ADDENDUM to State Boulevard Reconstruction Project
From Spy Run to Cass Street
Fort Wayne, Allen County, Indiana
Des. No. 0400587
DHPA No. 5903

Prepared December 12, 2014

This Addendum to the State Boulevard Reconstruction Project 800.11(e) Documentation is to incorporate the Consulting Parties Proposed Alternative (CPPA) as presented by Storrow Kinsella Associates in collaboration with Transportation Solutions, LLC. Through the alternative evaluation process it has been determined that the CPPA is not reasonable as it does not sufficiently address the project’s purpose and need. This document amends the following sections of State Boulevard Reconstruction Project 800.11(e) Documentation with discussion of the CPPA.

Sketch Plan

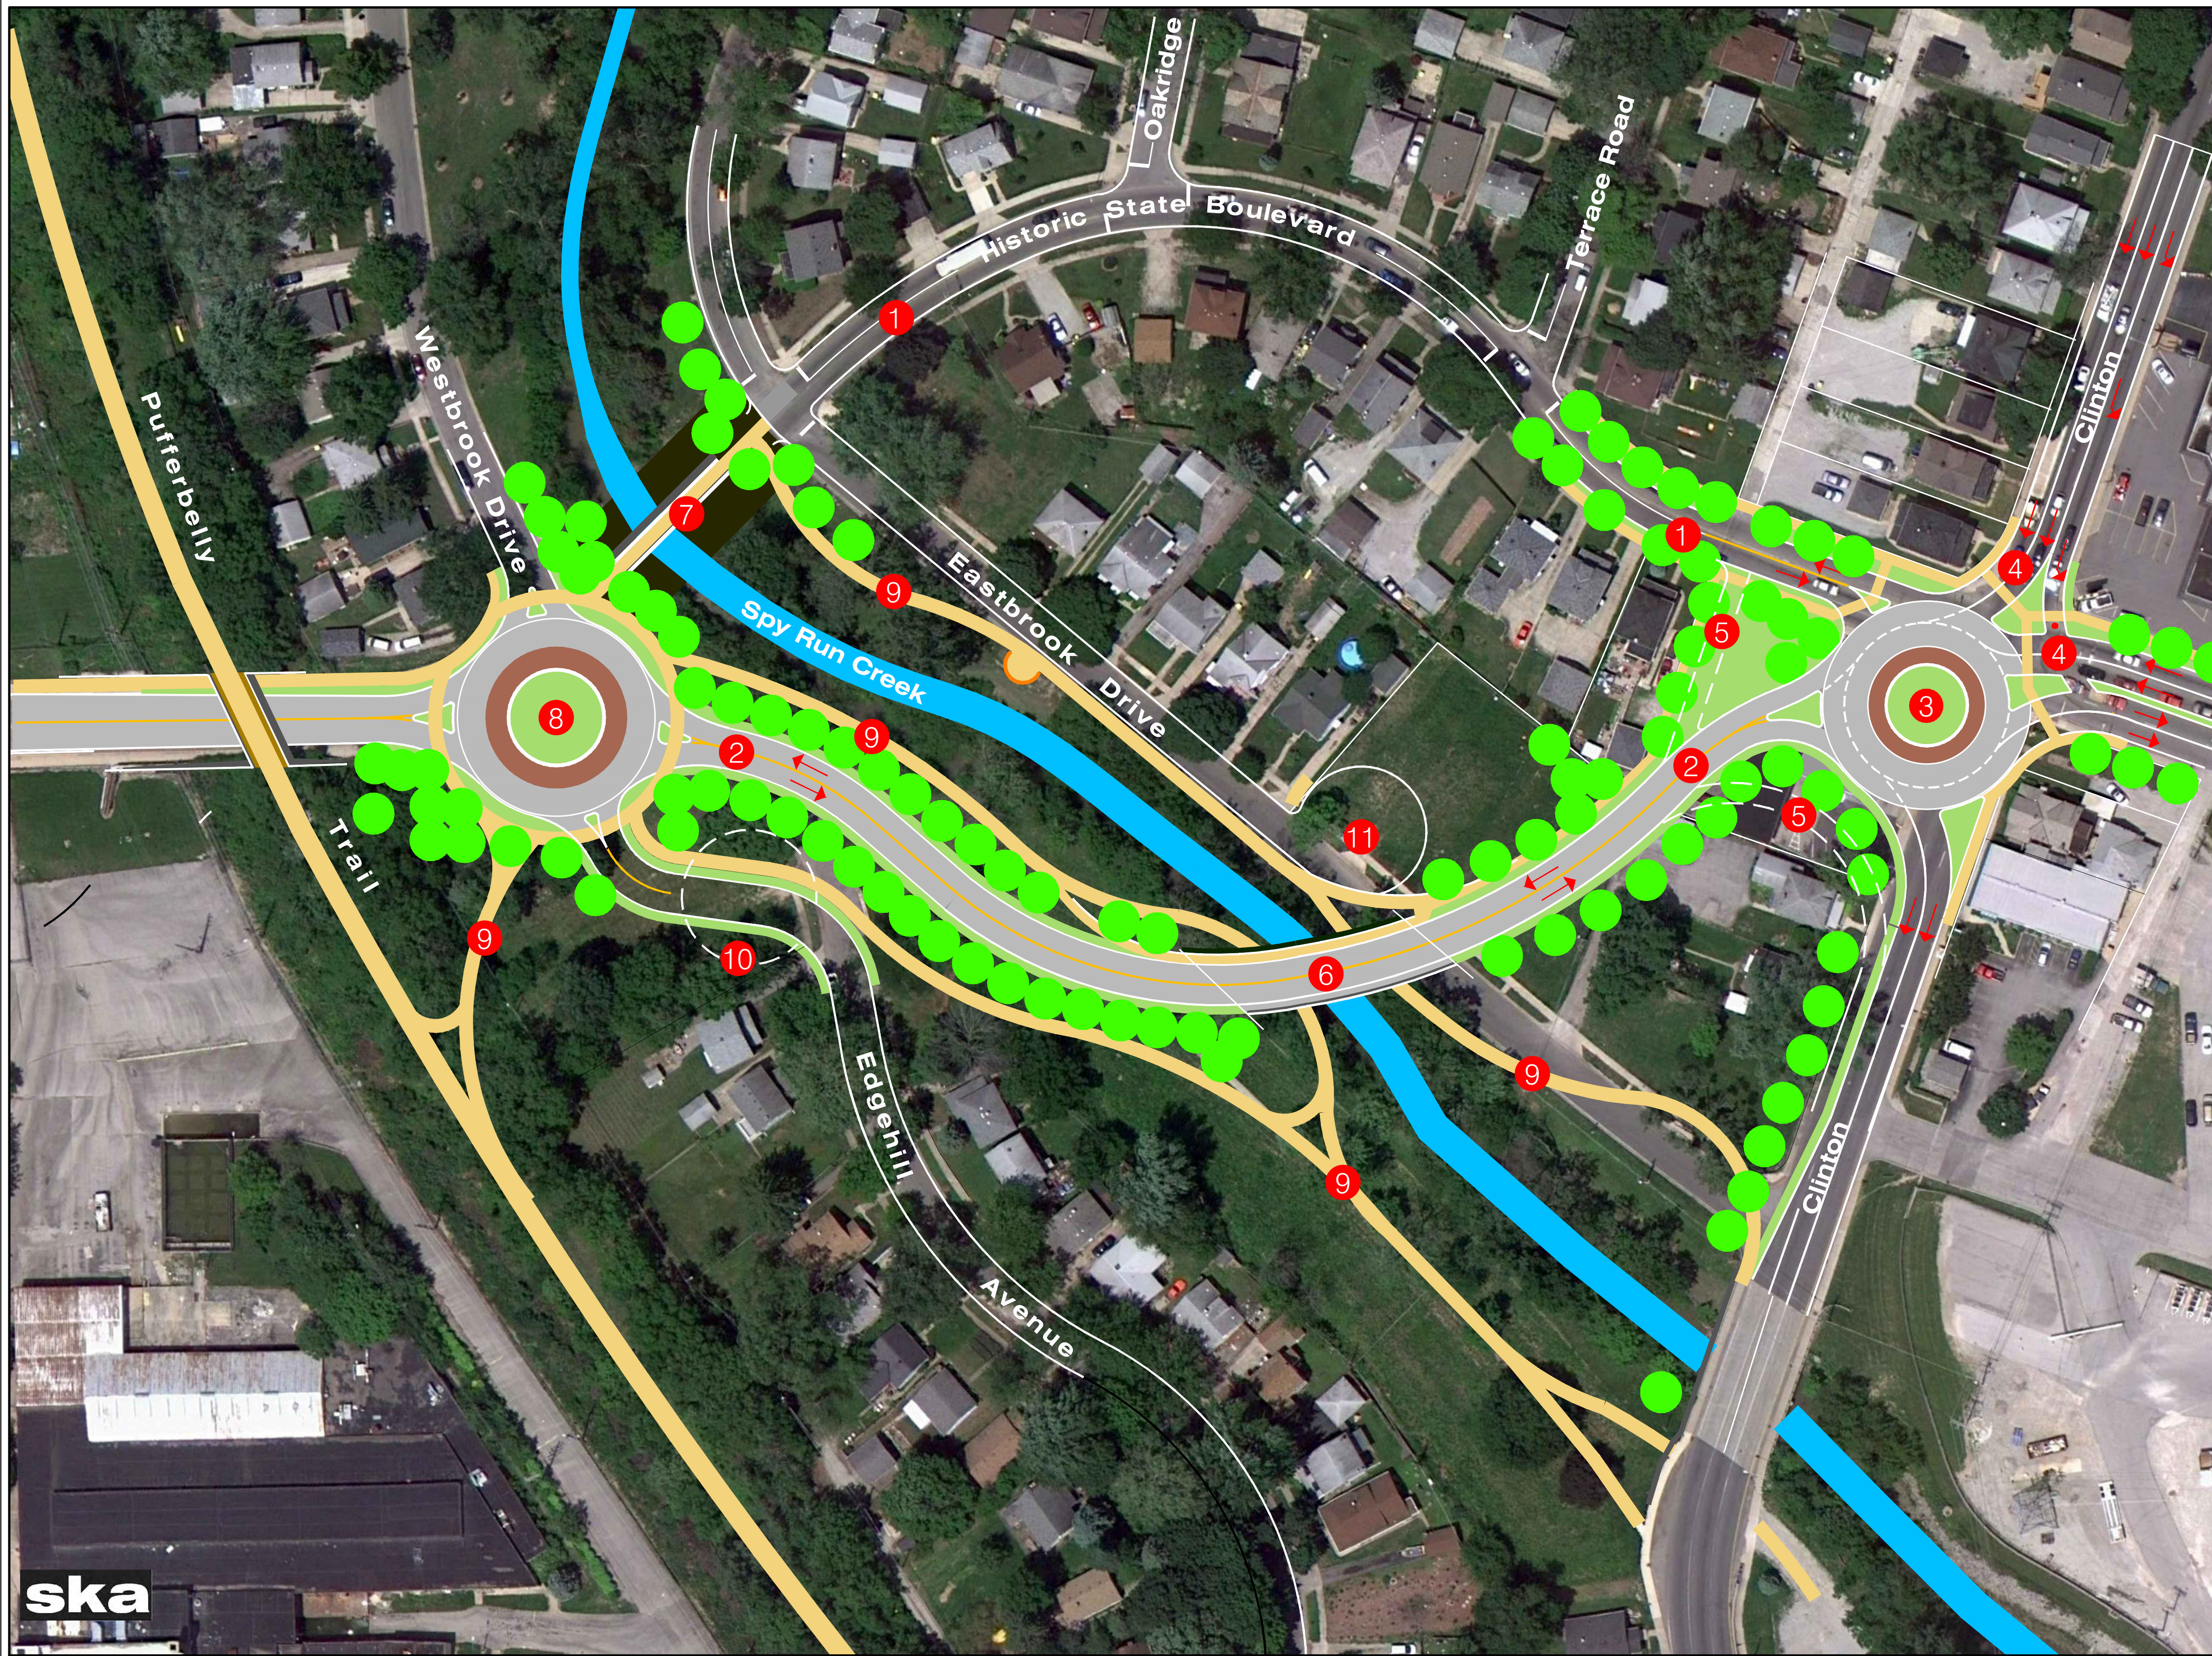
- 1 Historic State Boulevard convert as local street & bike boulevard
- 2 New State Boulevard alignment
- 3 Clinton/State 2-lane hybrid urban roundabout with signalized eastbound left turn bypass
- 4 "Smart" roundabout signal -metered approaches to create gaps and balance flow during peak periods, and to provide pedestrian crossing synchronized with those phases (short/rolling yield or stop signal phases)
- 5 Optional bypass lanes to reduce roundabout circulating traffic loads
- 6 New Spy Run Creek 2-lane bridge
- 7 Spy Run Creek bike/ped bridge
 - Retrofit existing bridge or
 - New multi-use path bridge
- 8 Westbrook/Edgehill single lane urban roundabout w/ local street access
- 9 Bike-Ped path system
- 10 Edgehill Avenue cul de sac alternative
- 11 Eastbrook Drive cul de sac

City's Preferred Alternative

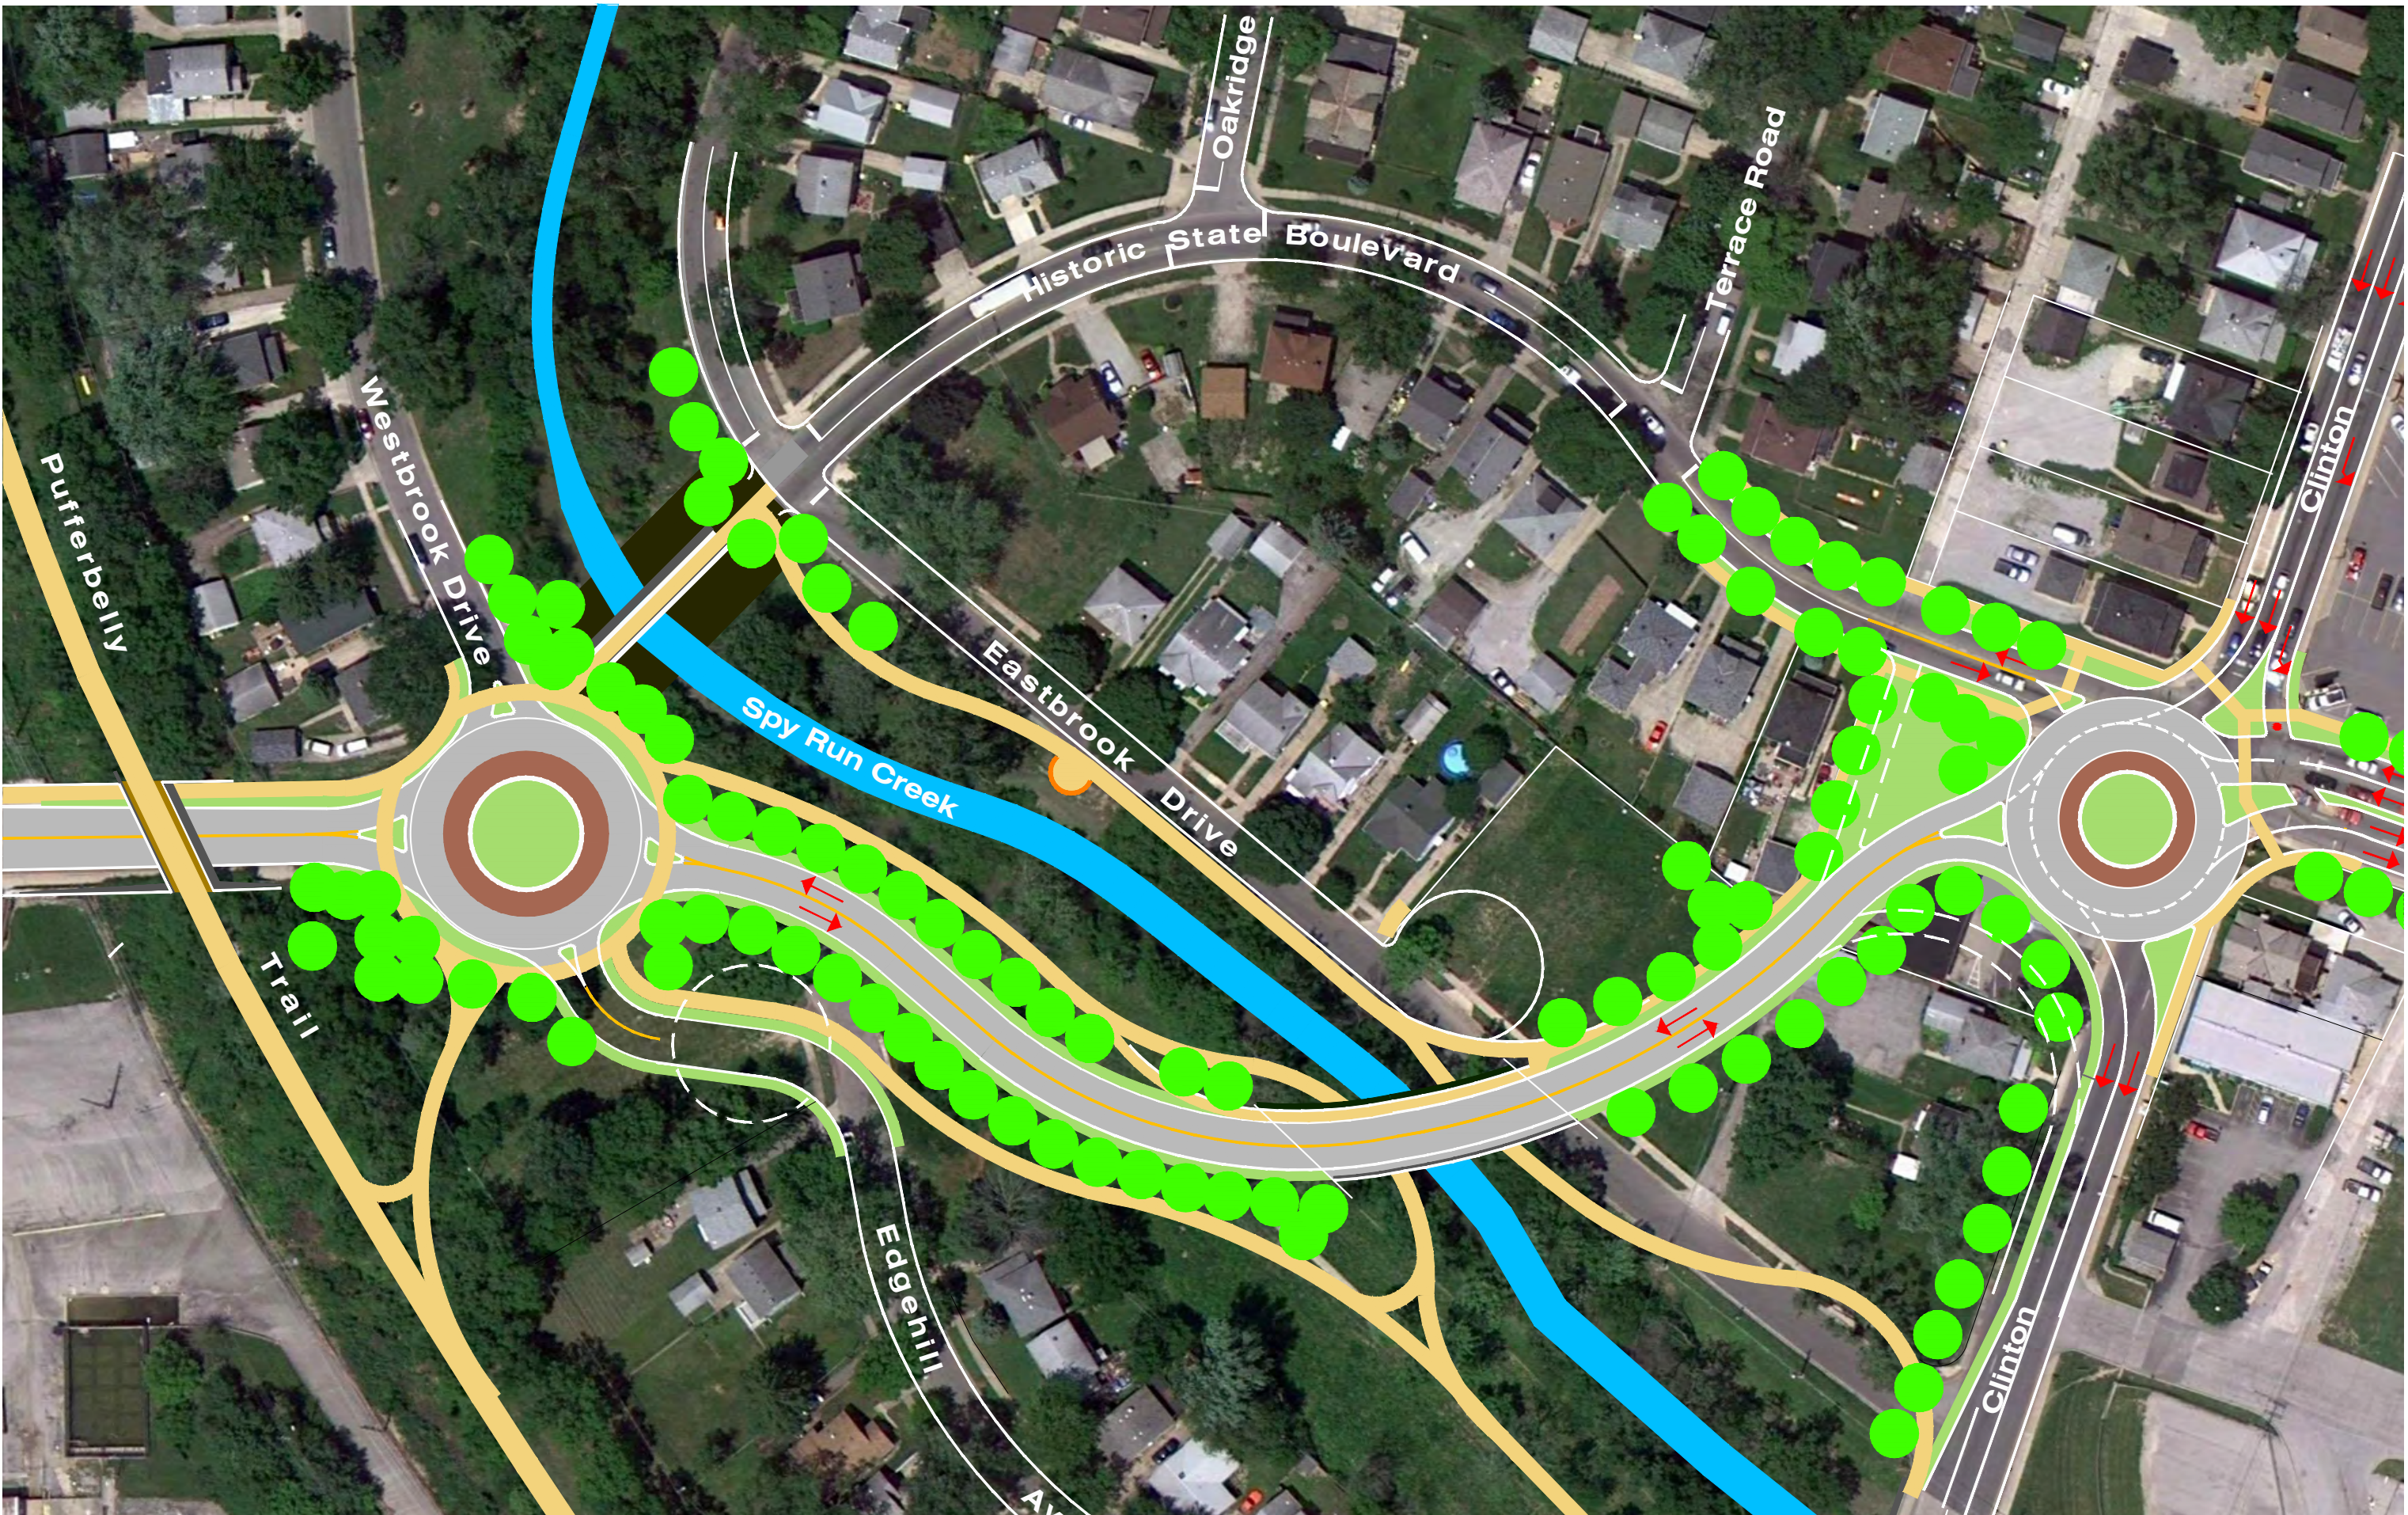
Shown above is a model of the City's Preferred Alternative; a new four lane roadway with raised median and/or center turn lane between North Clinton Street and Westbrook Drive. It is replacing a section of the existing two-lane State Boulevard in the City of Fort Wayne Park and Boulevard System Historic District.

The Park and Boulevard System Historic District represents a thoroughfare system designed in the early 1900's for the purpose of economic development, flood control, connectivity, and beauty. The proposed City's Preferred Alternative has many of the same purposes and characteristics, and, without reference to context, will be a significant upgrade to the City's thoroughfare system. However the segment between Clinton Street and Westbrook Drive does have historic context that the scale of the new boulevard will compromise.
